GLASTAR SERVICE BULLETIN 48

Mandatory

Subject: Elevator Bellcrank Clearance Inspection and Aileron Inspection Provisions.

Applicability: All GlaStar kits

Figure 2. Modified Elevator Bellcrank Installation for Improved Clearances

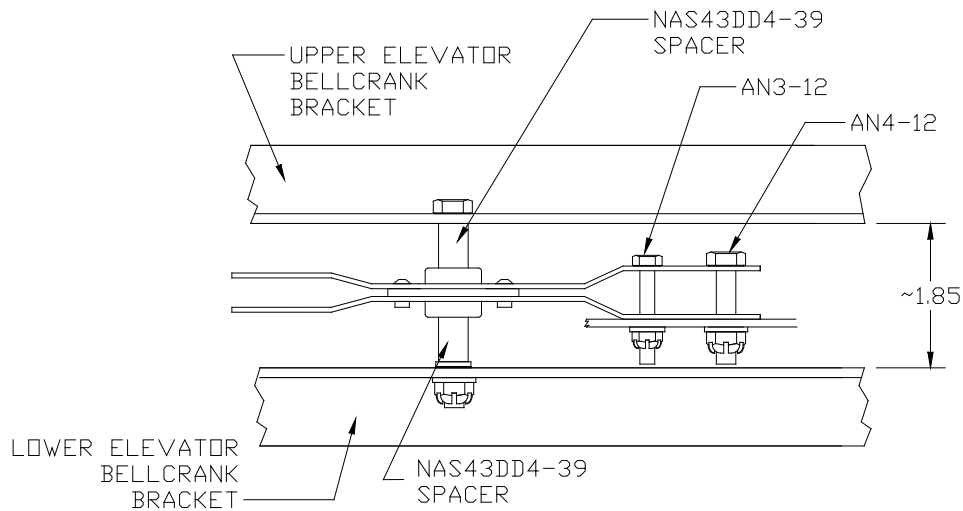
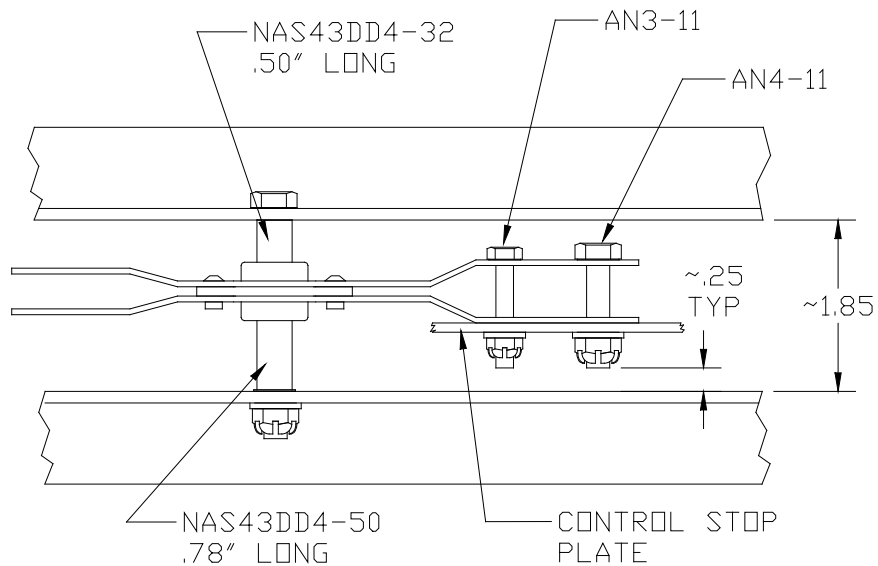
As the elevator bellcrank moves through its range of motion for controlling the elevator, adequate clearance should be maintained at all times between all moving parts to avoid potential interference and binding of the control system. When the builder first installs the upper and lower bellcrank brackets in the fuselage as prescribed in Figure 85 of Section VIII, the Assembly Manual does not give a controlling dimension, but rather just says to use the “clamped up assembly”. If the brackets are installed properly and parallel to each other, the distance between the upper and lower brackets should be approximately 1.85 inches as shown in Figure 1 below. Since the two NAS43DD4 spacers are of equal length, the bellcrank assembly is centered between the two brackets. But when the control cable, elevator stop and elevator pushrod hardware is installed, the clearance at the bottom of the two bolts shown in Figure 1 is marginal or inadequate.

Figure 2 below gives a more optimum arrangement when installing the bellcrank assembly between the upper and lower brackets. By using unequal NAS43DD4 spacer lengths, the bellcrank assembly can be shifted up providing more clearance to the bottom of the bolts. By going to AN3-11 and AN4-11 bolts, additional clearance can be gained and still have adequate grip length for the bolts through the bellcrank assembly and the control stop. The builder should aim for .25 inches of clearance between the bolts and the bellcrank brackets. We have observed that the elevator pushrod attach bolts on the bellcrank assembly tend to deflect marginally up under a positive or tail down load (approximately .05”). Therefore, slightly more clearance should be provided between the head of the bolt and the upper bracket.

For those airplanes that are already flying or which have all the control rigging done and the tail section closed out, the primary importance is an inspection of the system as you have installed it. Remove the lower fuselage inspection cover and with a mirror and adequate lighting, move the elevator controls through its range of motion and measure the clearances between the upper and lower ends of the three bolts on the bellcrank. **The minimum recommended clearance on the lower edge of the bolt should be approximately 3/16 inch.** If you find your clearance is less than the minimum, you can gain 1/8 inch by switching the bolts over to an AN4-11 and an AN3-11 from the AN4-12 and AN3-12 as specified in the assembly manual. If you need additional clearance, then use the NAS43DD4 spacers specified in Figure 2. **Before you attempt to replace any hardware, the cable tension will have to be released on the elevator control cables.**

The NAS43DD4 Bolt Spacers can be made from 6061-T6 or 2024-T4 aluminum with an outside diameter of .38 - .50 inch. The bare material should be primed for corrosion protection. A Service Bulletin Kit **P/N GSSB48KIT-1** is available through Glasair Aviation USA, LLC. This kit includes two new NAS43DD4 bolt spacers and the AN3-11 and AN4-11 bolts.

Figure 3. Small Inboard Cove Skin Cover Template

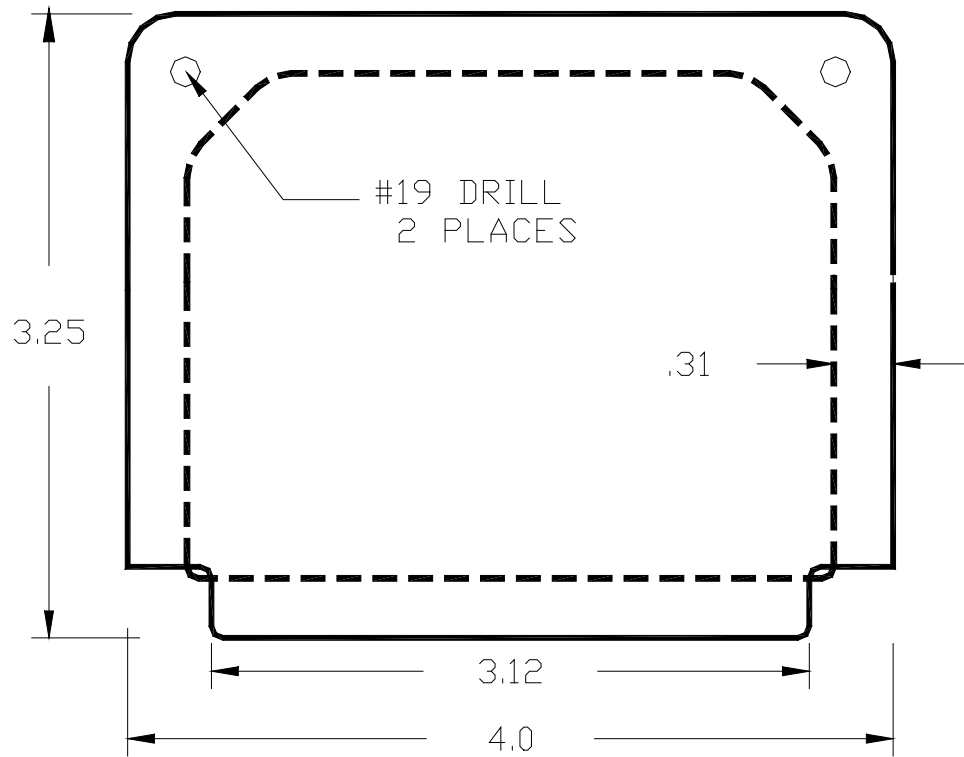
The flat pattern for the cover plates can be seen in Figures 3 and 4 below. The dashed line inside the perimeter is the profile of the access hole itself. (Do not cut this into the cover!) Use this template or cover when cutting the hole in the cove skin. Make sure you keep adequate edge margin for the two nut clips and number 8 screws that will hold the small cover down. The larger cover will use four screws and four nut clips each. The lower lip of the small cover is trimmed and joggled slightly to fit on the inside of the hole cut into the cove skin. The cove skins themselves are made from .016 thick aluminum skin. The covers could be made from .016, .020 or .025 aluminum. If you do not have any scrap material around to produce these covers yourself, a Service Bulletin Kit **P/N GSSB48KIT-2** can be purchased from Glasair Aviation USA, LLC. This kit includes sheet material for covers, screws and nut clips for four access panels.

Figure 5. Position of Access Cover in Flap Cove Skin

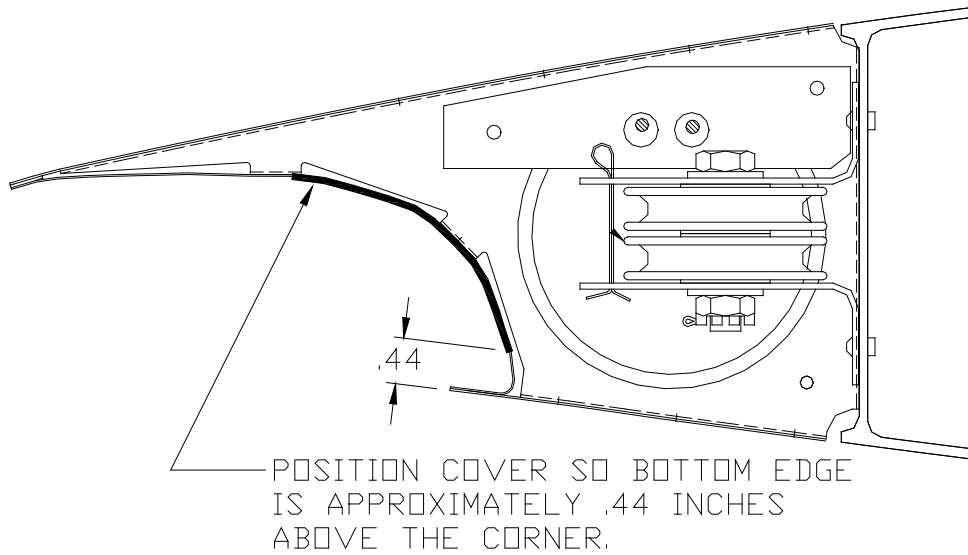
When positioning the cover to the cove skin, place the bottom edge approximately .44 inches up from the corner as shown in Figure 5. Your corner fillet on the cove skin might vary slightly, so position the cover where **you** deem the best fit to access the pulleys or fairleads. Mark everything out with a felt tip marker first and make sure it will all work as planned. When you are ready to cut the actual access hole in the cove skin make sure you are only cutting the hole to the size shown by the dashed line on the cover template shown in Figure 3 and 4. Round the corners and position and or trim for the nut clips until the holes line up with the cover. (These are a 3/8 inch throat nut clip, so keep your edge margin 3/8 inch) The recommended position for the **outboard edge** of the outboard cover plate is one inch inboard of the flap/aileron cove transition or 109.50 inches from root of wing. The recommended position for the **outboard edge** of the smaller inboard cover plate is 44.5 inches outboard from the root of the wing. Deburr all sharp edges and clean up the aluminum shavings if you are working in a wing with the cove skins already installed.

Finally install the P/N 450-0211-081 Nut clips over the cove skin. Then secure each Cover Plate over the hole with AN526-8R6 Truss Head screws or equivalent ones of your choice.
